ZONING COMMITTEE STAFF REPORT

1. **FILE NAME:** Victoria Park Apartments Phase 3 **FILE #** 16-015-194
 2. **APPLICANT:** Nova Classical Academy **HEARING DATE:** March 24, 2016
 3. **TYPE OF APPLICATION:** Appeal of a Planning Administrator decision
 4. **LOCATION:** 763 Kay Ave, SW corner at Mercer Way
 5. **PIN & LEGAL DESCRIPTION:** 142823210045, Victoria Park Lot 1 Blk 6
 6. **PLANNING DISTRICT:** 9 **PRESENT ZONING:** T3M
 7. **ZONING CODE REFERENCE:** §66.344(c); §61.701
 8. **STAFF REPORT DATE:** March 17, 2016 **BY:** Bill Dermody
 9. **DATE RECEIVED:** March 3, 2016
-

- A. **PURPOSE:** Appeal of Planning Administrator approval of changes to the Victoria Park Master Plan to allow a 49 ½ ft. high apartment building.
- B. **PARCEL SIZE:** 160 feet (Kay Avenue) x 142 feet (Mercer/Victoria) = 22,720 square feet

1. Site Plan
2. Building Elevation.w/ Height

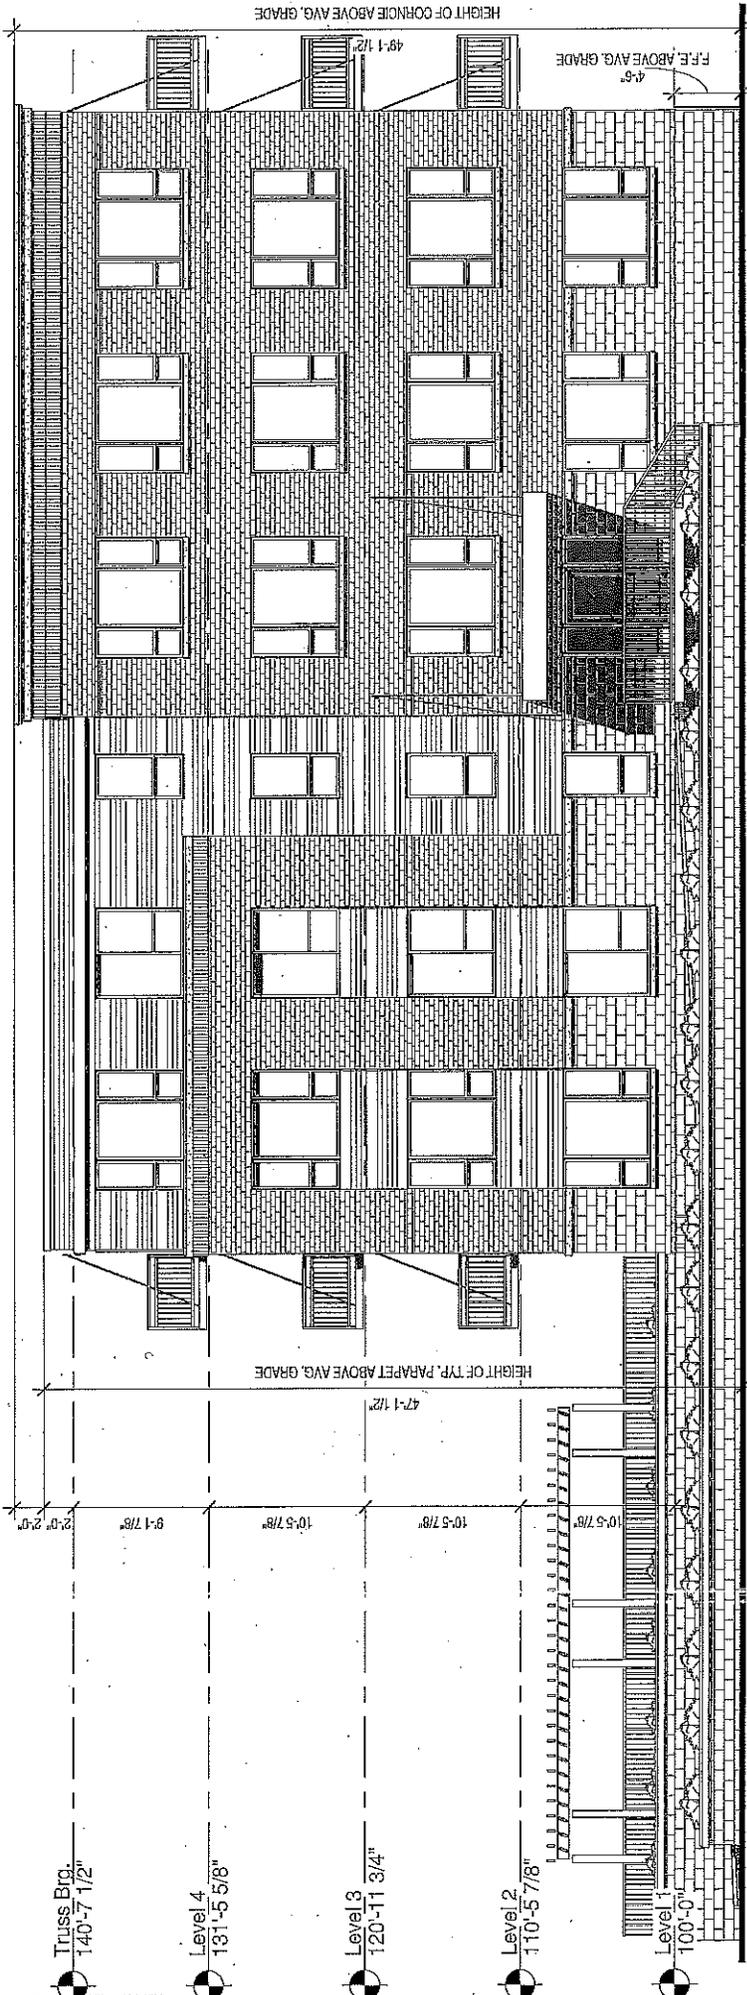
The height of the building at its tallest point as measured per zoning code (from top of highest roof down to average grade plane height) is 49'-1 1/2". (See attached elevation). This request for increased height will meet the Victoria Park master plan in designing for residential buildings primarily in the 2-4 story range. The extra height requested is needed to construct a typical apartment building having 9'-0" ceilings. With a typical floor-to-floor height of 11'-0" in wood constructed buildings, in addition to a roof parapet and a Level 1 Floor stepped above outside grade, typical 4-story buildings are several feet taller than 40'. The proposed design (see elevation) shows a taller front entry corner with a higher brick parapet, and then stepping down to a 47'-1 1/2" height.

The building layout per Plate 7 at our Phase 3 property indicates a u-shaped 'townhomes' development. After reviewing several site plan options, we determined the proposed L-shape building to provide the most functional and useful floor plan and the most respectful in providing additional setback from the adjacent Nova School building. Square buildings are more suitable for offices and very difficult for housing. Having such a small site available (122' x 140' in useable building footprint), we see underground parking and **apartment homes** as the highest and best use of the property. The corner courtyard will add visible features like canopies, planters and landscaping for a nice experience to pedestrians passing by.

1. The changes you are proposing to the *Victoria Park Master Plan* constitute a minor modification.
2. Both proposed changes - an increase in height of 9'6" for your proposed building and a change in building type from townhome to rental apartment - are consistent with the core design and planning principles noted on p. 5 of the *Victoria Park Master Plan*.

Your proposed modifications are hereby approved. I understand that you have also applied for a Conditional Use Permit to increase the height of your proposed building from 45' to 49'6". The Planning Commission will rule on that application separately.
